RECEIPT DATE: 2/27/17 ONSITE SEWAGE DISPOSAL SYSTEM P 560556

PROPERTY ADDRESS: 12300 Carol Drive

SUBDIVISION: Fulton Manor LOT: 7 TAX ID: 05-417945

From: Williams, Jeffrey
Sent: Wednesday, February 15, 2017 9:16 AM
To: 'Shane Gray'
Subject: RE: 12300 Carol Dr - Septic System Location

A 49337E

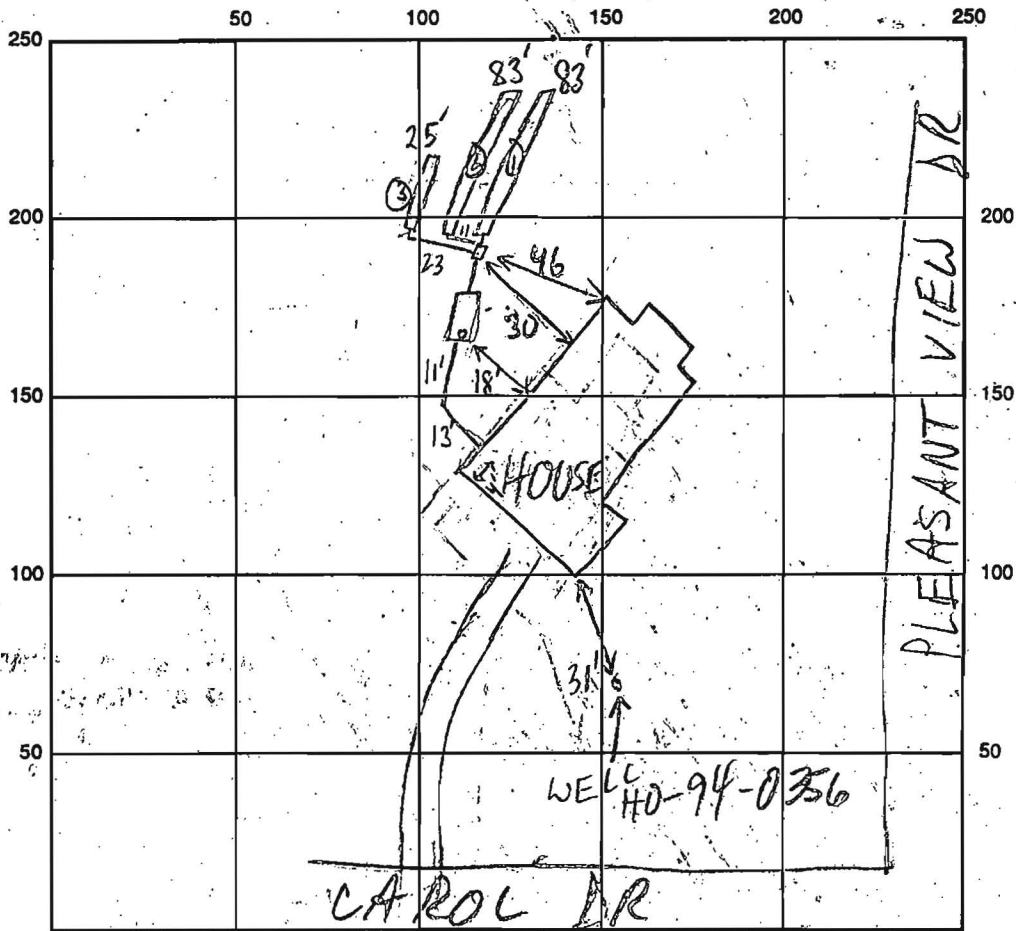
REMARKS: 12/14/95 ADVISED INSTALLER TO INSTALL TRENCHES
OF ROUGHLY EQUAL LENGTH IN FUTURE - CONTINUE MR
12/19/95 OK TO COVER MR RS

SITE INSPECTION SHEET

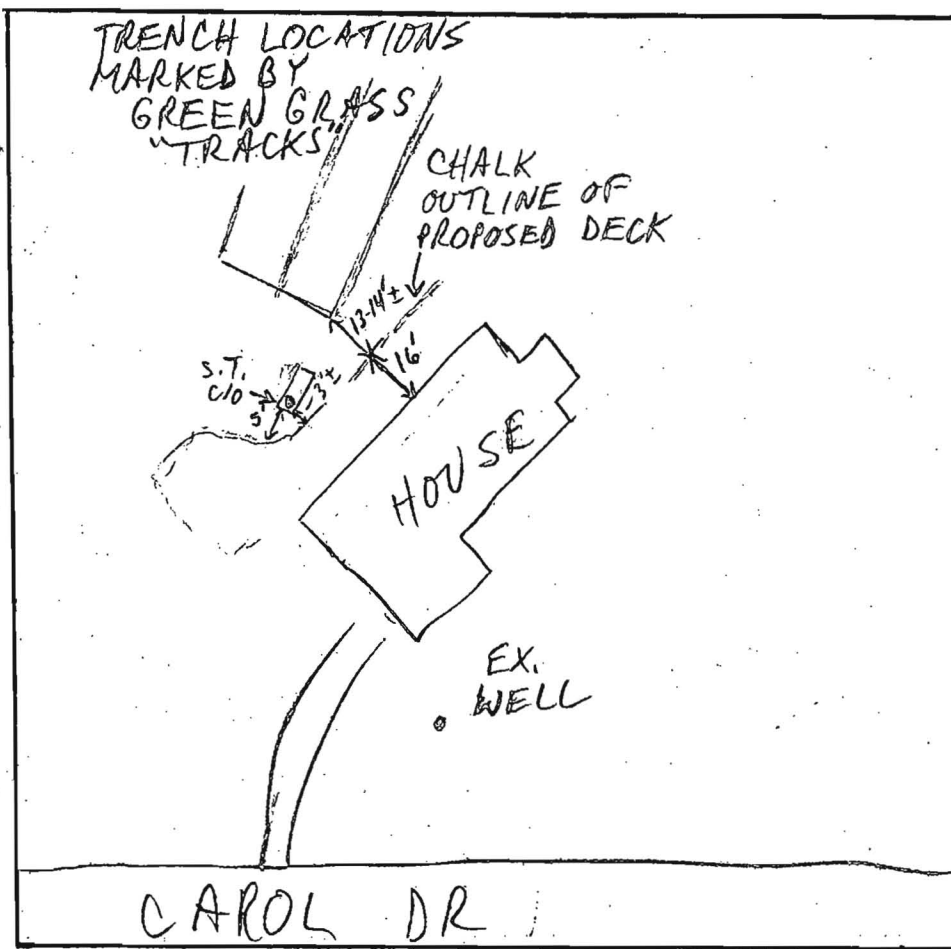
COMMENTS: 7/29/97 PROPOSED DECK 2' TO EX. S.T. - UNACCEPTABLE

7/31/97 T/C w/OWNER: ALTHO CONCESSION TO 5' SETBACK HAD ALREADY BEEN GRANTED BY ALM, HE WANTED FURTHER SETBACK REDUCTION. I ADVISED THAT WAS NOT POSSIBLE DUE TO SIG. POTENTIAL FOR IMPACT TO S.T., AND REDESIGN OR S.T. RELOC. NECESSARY. SIMILAR INFO COMMUNICATED TO DECK CONTRACTOR SEPARATELY; HE WILL WORK ON SOLUTION

PLEASANT VIEW DR
RESOLVED
8/15/97
MR

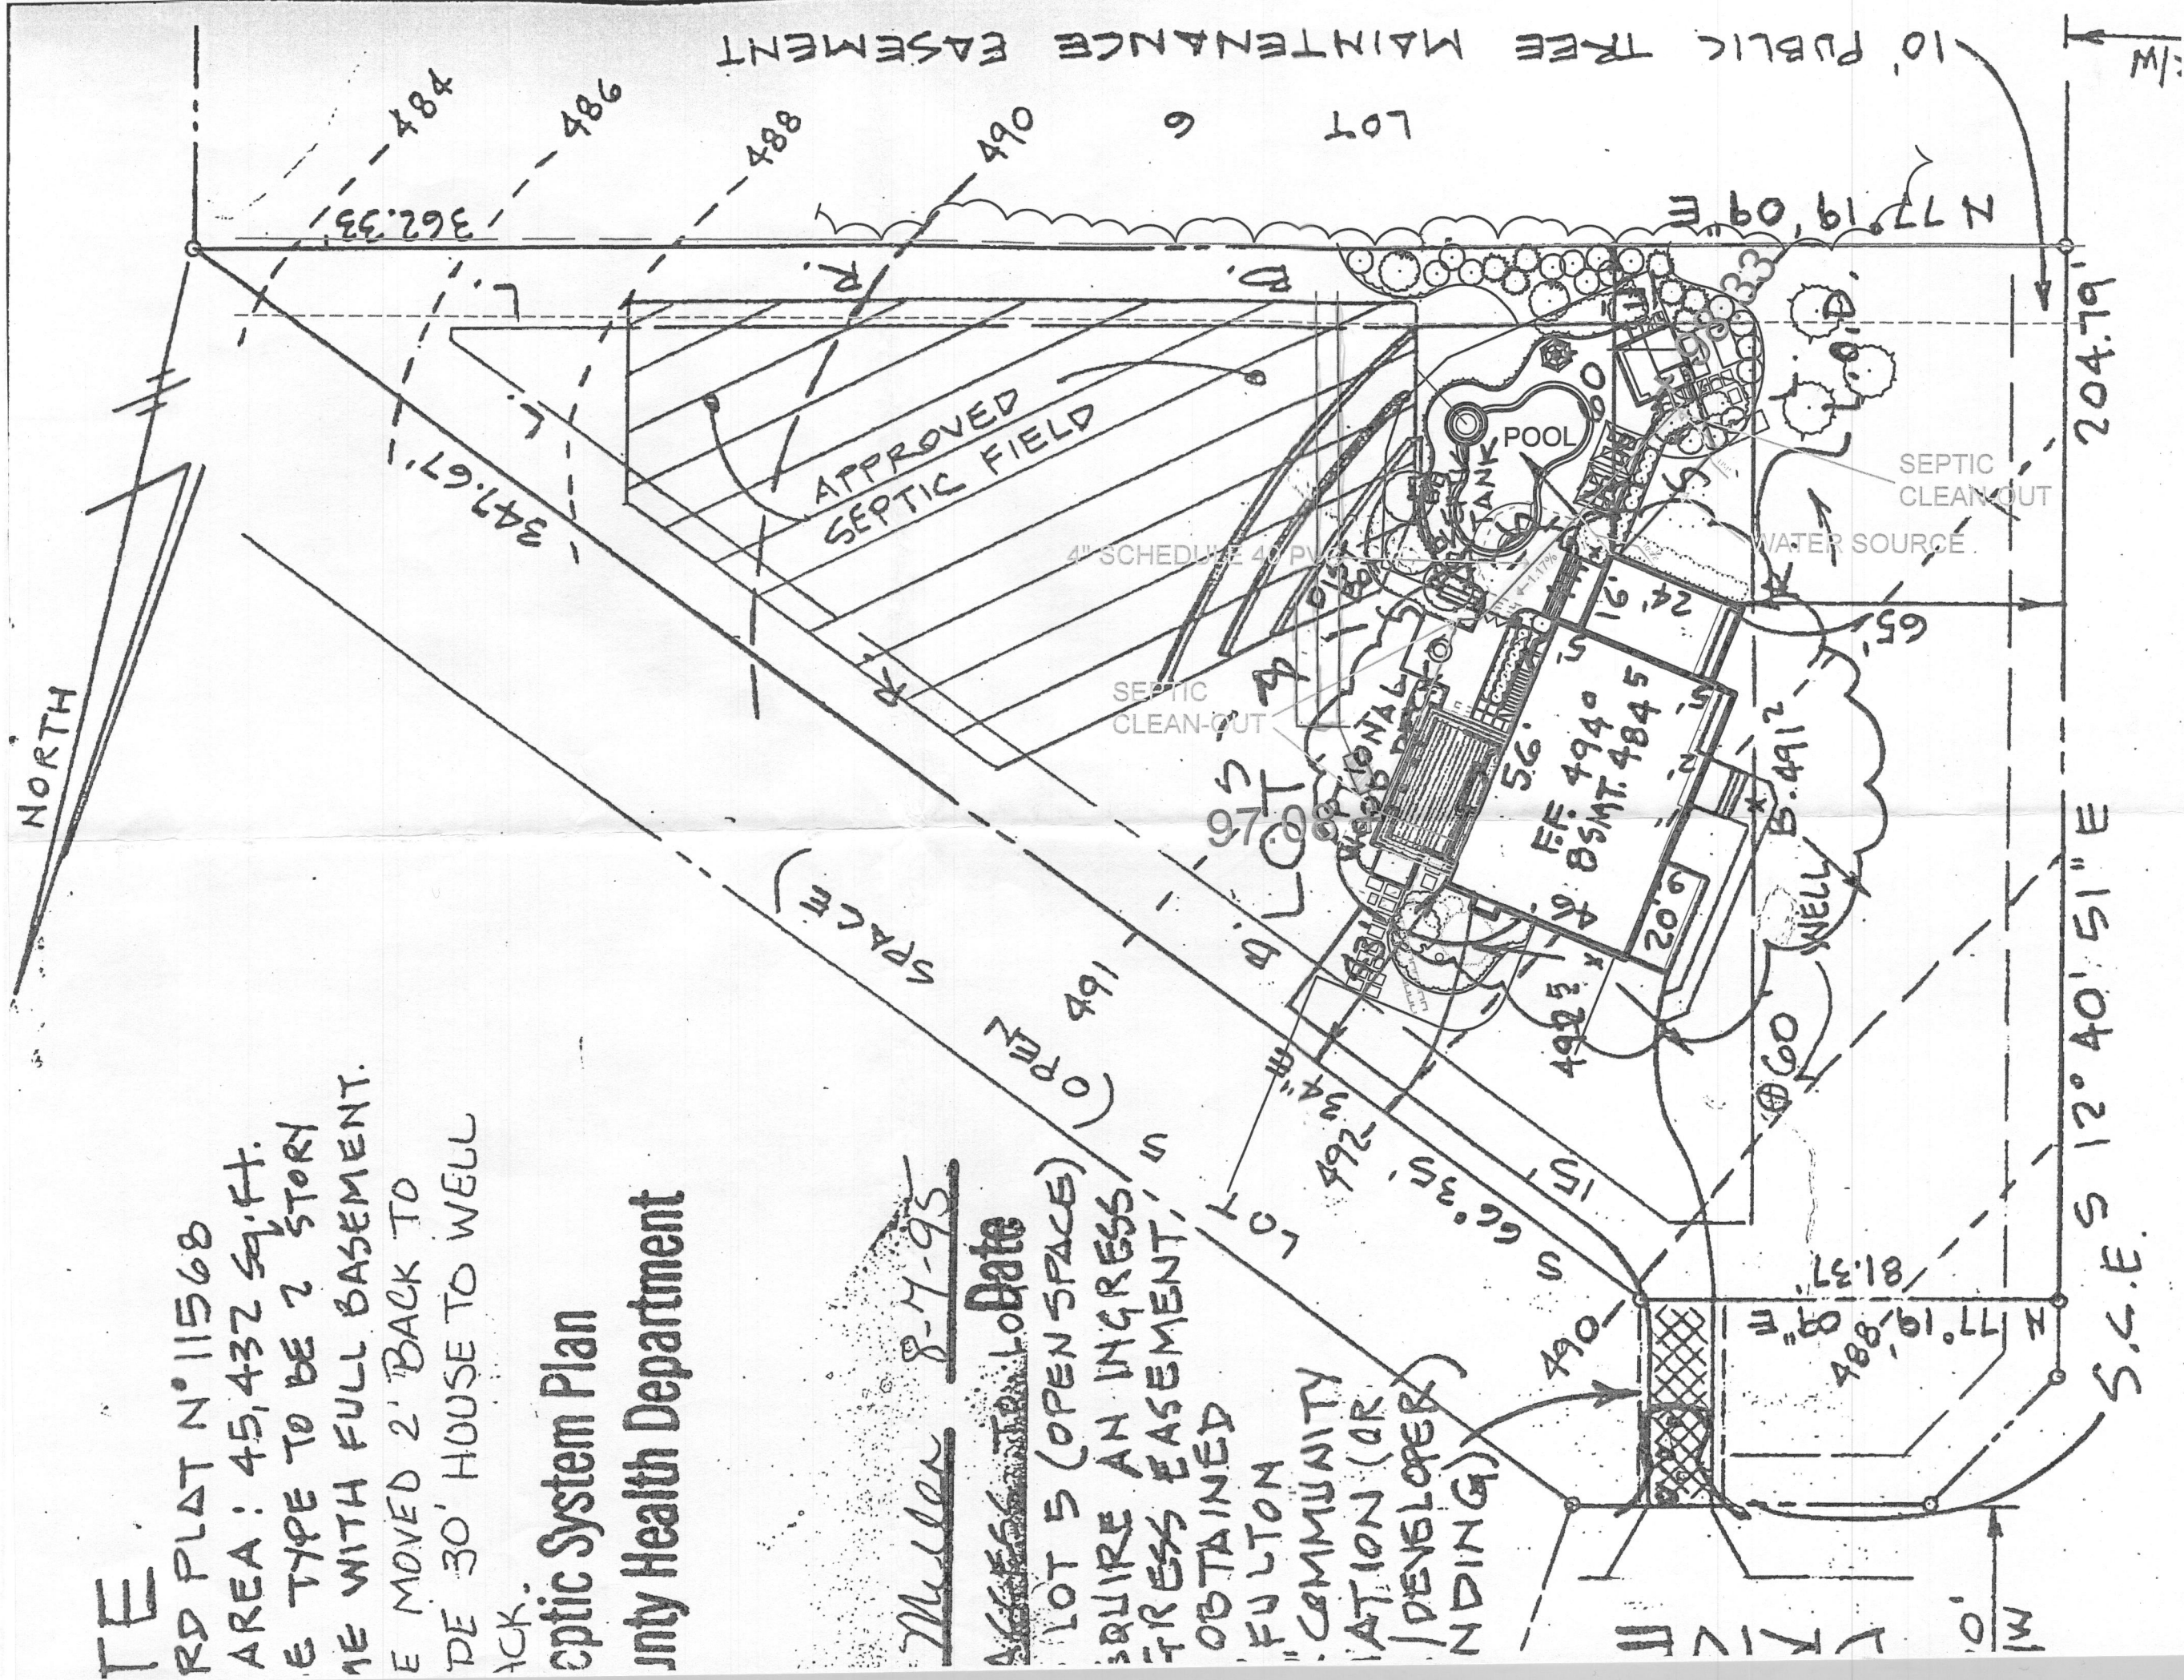
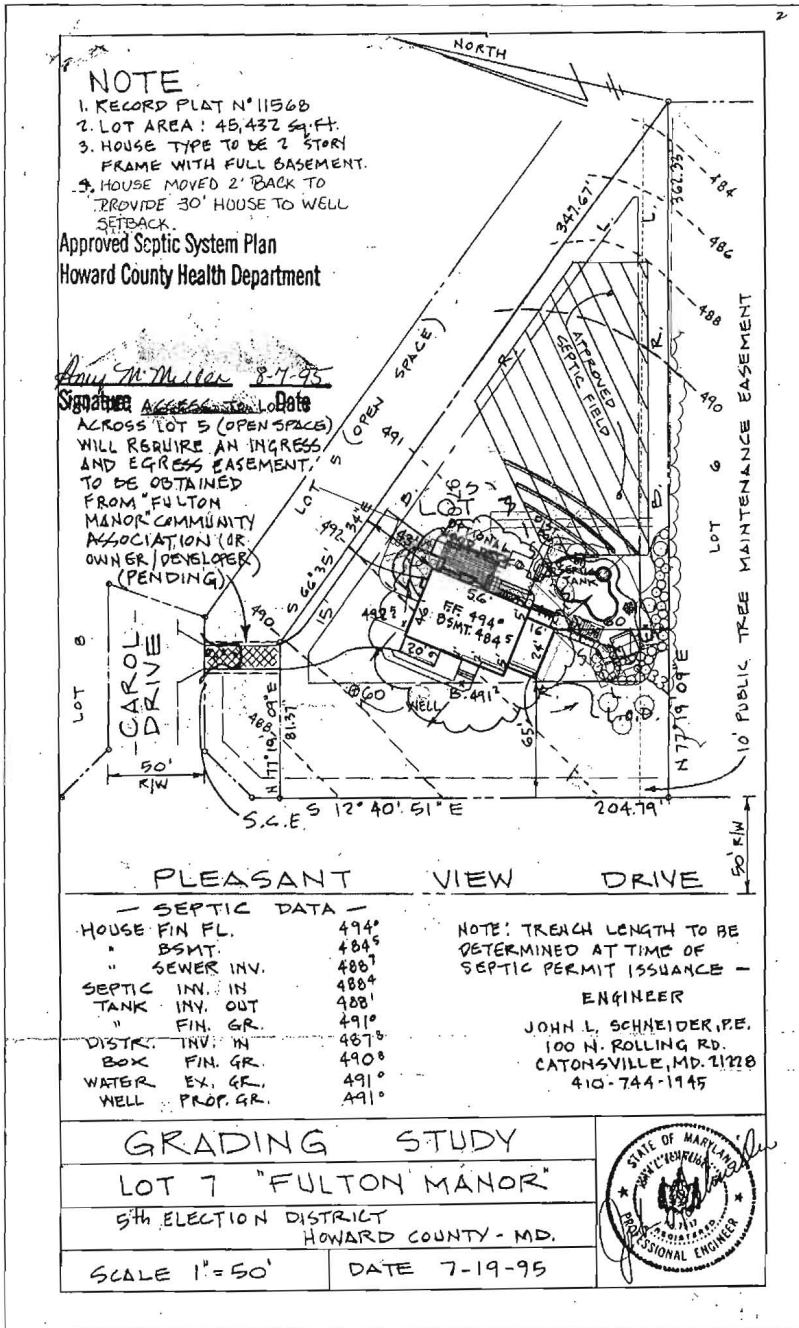
This plan could be acceptable if you specify a 4" line. Did you get a field measurement of the existing line elevation? Is the line leaving the pool house from under the slab? At 1.17%, there is no room for error in elevations. There is a very real possibility that something could be off and the fall will not work out. Please note that if the installer is not able to achieve at least 1% fall across the full length of the line, they will need to switch to a pumped system. This would require either a modification of the plumbing permit to add an interior ejector pit or modification of the septic permit to install a minimum 1000g single compartment approved style tank with a grinder pump outside the building.

- What are the elevations of the line leaving the pool house and the line at the connection to the existing sewer?
- What is the size and material of the line. It must be labeled on the plan. Schedule 40 PVC is typical.
- Is this a gravity line or a force main. If gravity, the line must have at least 1% fall and a cleanout shown at the outside of the pool house, at the tie-in, and every 70' in between. If a force main, add a note that there will be an interior ejector pit and note the diameter of the force main. Include a detail of the proper connection to tie in the force main to the existing sewer line.
- The proposed line appears to go through a lot of existing landscaping and under the existing deck. Is this homeowner ok with this? The location on this plan is where we will expect the actual line to be installed.

PROPOSED SEPTIC LINE FROM POOL HOUSE BATHROOM TO EXISTING LINE TO BE INSTALLED WITH 4" SCHEDULE 40 PVC.

PROPOSED SEPTIC LINE FROM POOL HOUSE BATHROOM TO EXISTING LINE TO BE GRAVITY LINE, FALLING AT A RATE OF 1.17%

PROPOSED SEPTIC LINE FROM POOL HOUSE BATHROOM TO EXISTING LINE TO BE INSTALLED WITH SCHEDULE 40 PVC.
PROPOSED SEPTIC LINE FROM POOL HOUSE BATHROOM TO EXISTING LINE TO BE GRAVITY LINE, FALLING AT A RATE OF 1.17%
